DPD# 3019544
718 RAINIER AVE S
EARLY DESIGN GUIDANCE
MEETING 2
AUGUST 11, 2015

TABLE OF CONTENTS

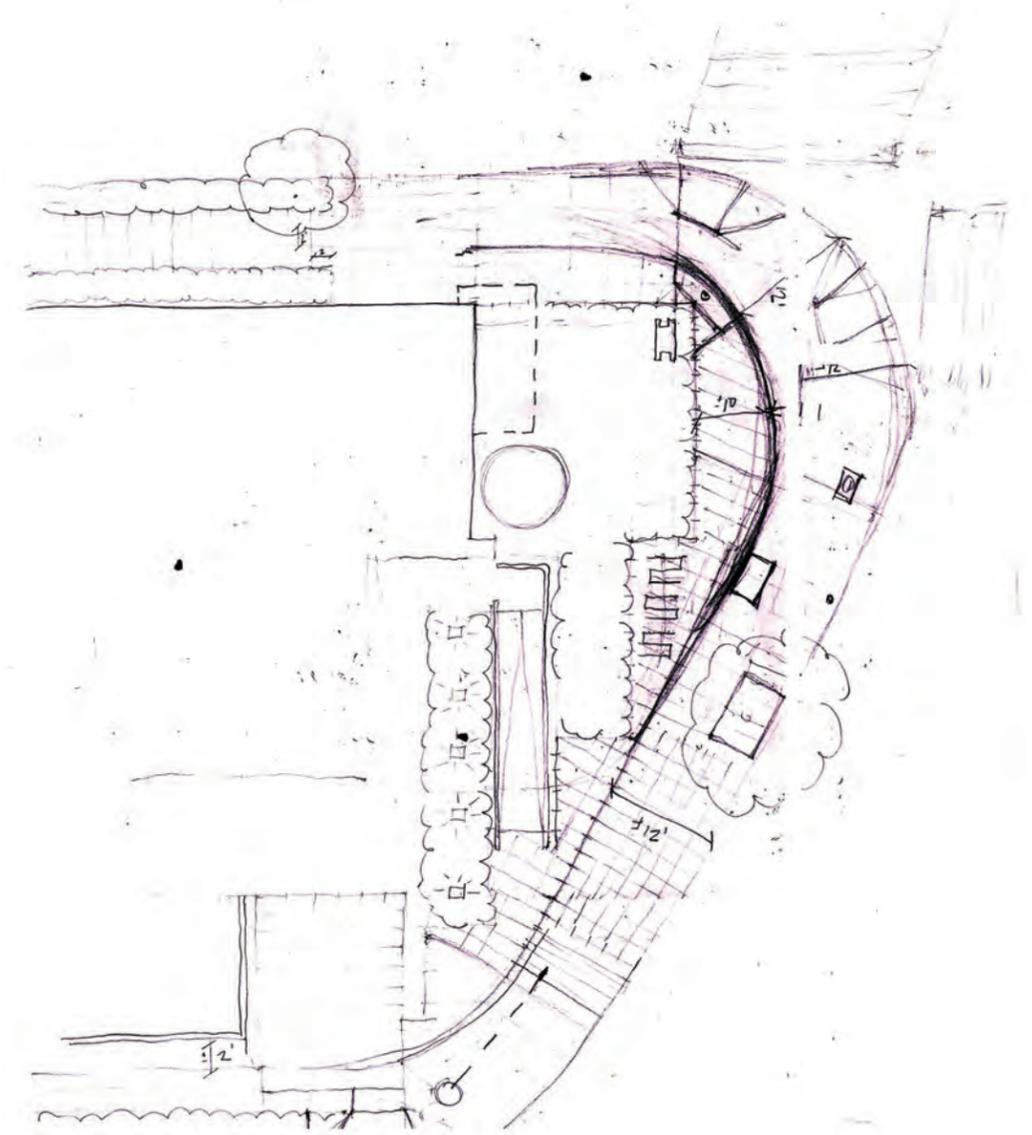
1 The Board directed the applicant to further develop the massing options; thoughtfully consider the height, bulk, and scale to create pedestrian oriented streetscapes along all street frontages. (Guidelines CS1-C, CS2-B, CS2-C, CS2-D).

2 Due to zoning transition, the Board recognized that the alley façade will be highly visible. The Board was concerned with the massing along the alley and directed the applicant to develop the options showing consideration and appropriate transitions to the adjacent zone. For this area, the Board noted that Massing Option 2 is the least successful and could be broken up to provide additional modulation, while Option 3 shows more of a successful transition. Create a step in perceived height, bulk and scale between the anticipated development potential of the adjacent zone and proposed development. (Guidelines CS1-C2, CS2-D3, DC2-A)

3 The southwest corner is visually prominent and the Board recommended distinguishing the corner with massing and ground level treatment. Expand the south setbacks and erode the massing at the corners. (Guidelines CS2-B, CS2-C, DC2-A)

4 Acknowledging that the texture and modulation along Rainier Ave S seems successful in expressing the form and scale, the Board directed applicant to develop the concept for the other frontages to ensure all facades are well proportioned, in particular when viewed from the street. (Guidelines CS2-B, DC2-B, DC2-D2)

RESPONSE Massing Option 4 is provided in this packet. Option 4 builds on the angled Rainier massing presented in Option 3 and draws on the more generous Rainier/Dearborn corner setbacks presented in Option 2. Option 4 is further developed to address concerns about massing, perceived building scale and active uses all around the site.

RESPONSE Alley massing has been further developed. Option 4 includes new or increased massing setbacks at Levels 3, 5, and 6. The setbacks create 4-story ground related massing that is in scale with multifamily building heights across the alley. The setbacks help reduce the perceived scale of the building and provide outdoor patio space at multiple floor levels along the alley.

At street level, Option 4 proposes landscape and hardscape details to make the alley more pedestrian friendly. Parking entry and trash pickup have been centralized to allow for landscape edges at both ends of the alley.

RESPONSE Corner massing and ground level treatment at/around the corner have been revised in Option 4. The revised option shows a singular, highly transparent corner volume grounded on both sides by adjacent ground-related building massing. Corner setbacks to the south and west have been increased to be more in line with setbacks shown in Option 2, which were preferred at EDG 1. The setbacks also respond to site observation of pedestrian circulation patterns and existing, immovable sidewalk obstructions at the corner (signal pole, fire hydrant).

RESPONSE Each street/alley frontage has been further developed in Option 4. Stepped setbacks along Dearborn, Lane and the alley create 4-story ground-related massing that wraps the building starting at Dearborn, continue through the alley, and around to Lane. At upper levels, the building sets back and creates outdoor space for residents that face the alley. At the north alley, Option 4 has sloped clerestory roofs informed by the more traditional character of Lane. Going forward, facade development, glazing organization and material decisions will be made to support expression of this stepped down massing.

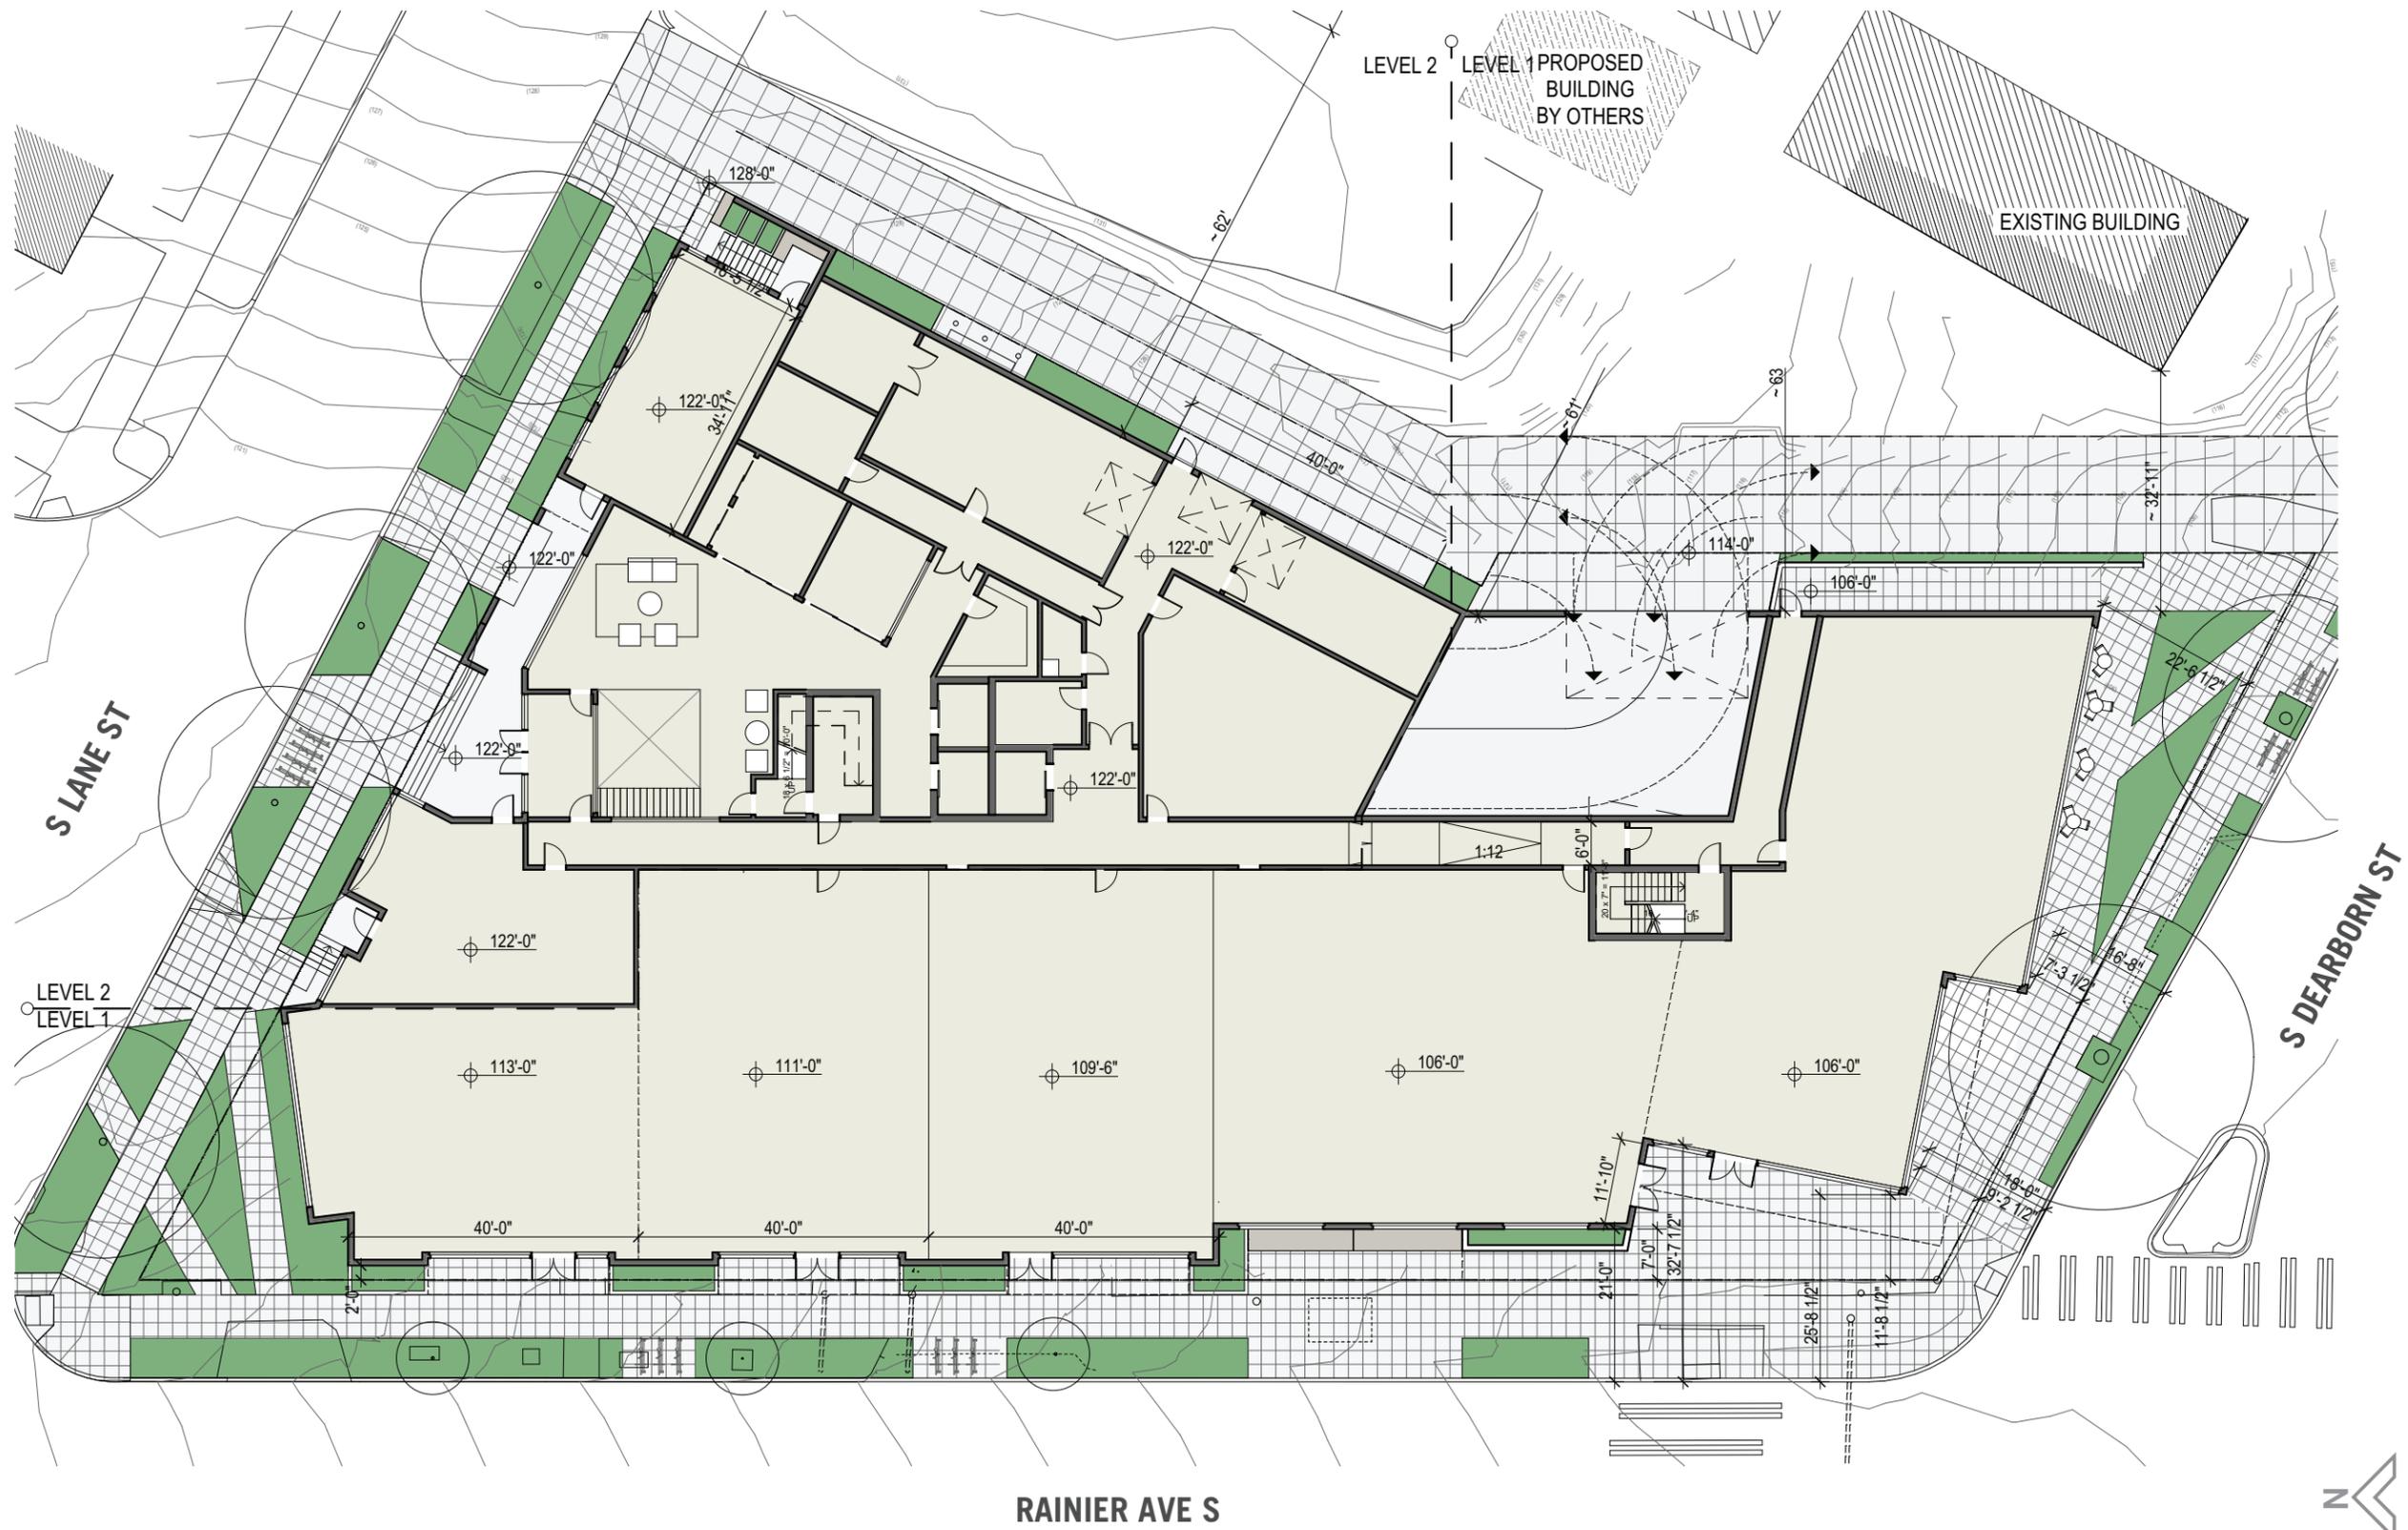
8 The Board was concerned with the character of the S Lane St frontage and urged the applicant to develop the scale and treatment of this edge. Consider how the commercial wraps the corner and provide residential character to relate to the context. (Guidelines CS2-B, PL2-B-3, PL3)

RESPONSE Lane street frontage has been further developed for scale, massing and more active uses at street level. Commercial transparency has been added at the corner of Lane and Dearborn. Further east, a small commercial space and a live-work unit have been added to the Lane frontage. The live-work unit is at the Lane/alley corner. Each of the new commercial uses has its own stoop as well as accessible access through a covered access gallery that also serves the residential lobby. Overall, the intent of these refinements is to bring more pedestrian activity and more transparency to Lane St.

The building massing has been refined along similar lines as the alley. Option 4 has 4-story ground related massing with a 4' setback at level 6 to provide better transition to the LR3 zone to the east.
